Re: Docket No. SB-2021-01 – In Re: Revolution Wind, LLC’s Application to Construct and Alter Major Energy Facilities in North Kingstown, Rhode Island

EFSB 2-1

Regarding the October 3, 2021 written public comment filed with the Energy Facility Siting Board by Donald J. Dennehy Jr., please provide answers to each of the questions he posed.

Attachment EFSB 2-1

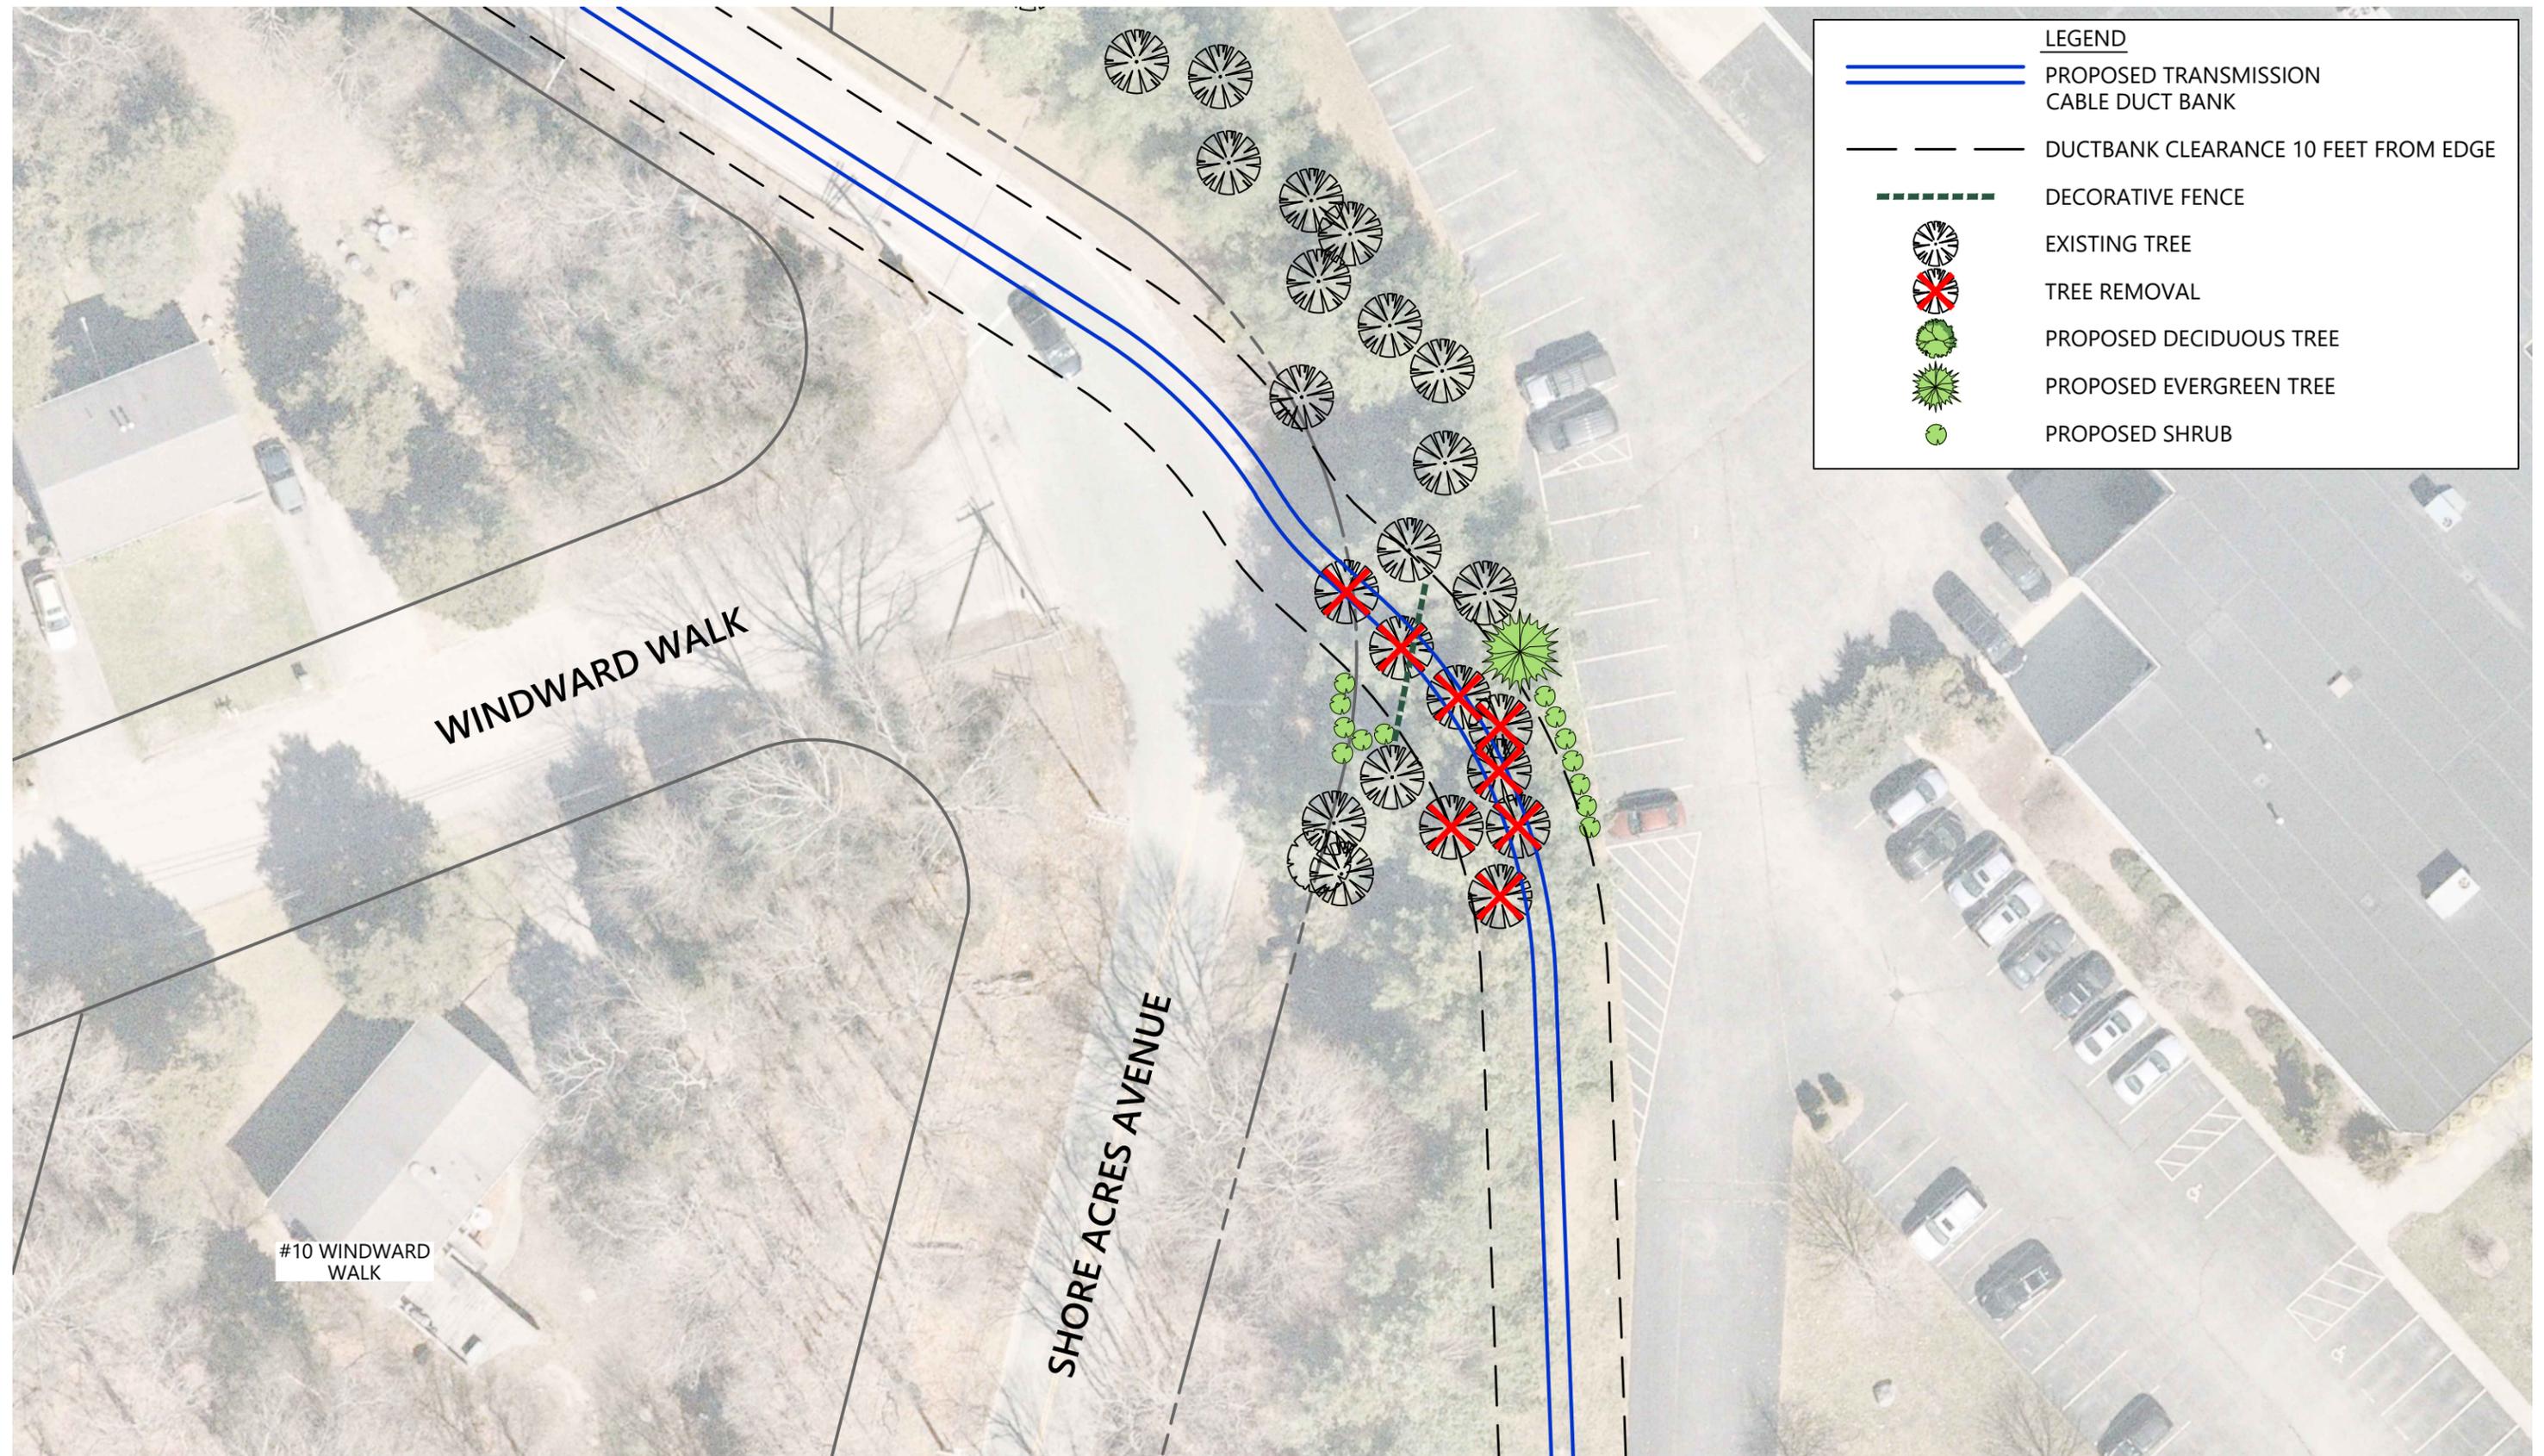
6. *If the route through the residential area is used, we will lose the current buffer zone between the street and the industrial park, which was placed to reduce sight lines, noise, and light pollution. What mitigation is planned for this?*

Revolution Wind has been working with the property owner at 135 Circuit Drive to specifically address the installation of the transmission line and provide a robust landscaping solution. Attachment EFSB 2-1 depicts a draft landscaping plan developed to maintain screening while safely operating the transmission line.

Eight existing trees ranging in size from 6 inches to 18 inches in diameter will be removed in the hedgerow separating 135 Circuit Drive and Shore Acres Avenue where the Onshore Transmission Cable will be constructed. This area will be restored by replanting with 13 shrubs and one tree and a decorative fence over the duct bank that will serve to replace the buffer as the new plantings mature. These plantings will reduce sight lines, noise and light pollution.
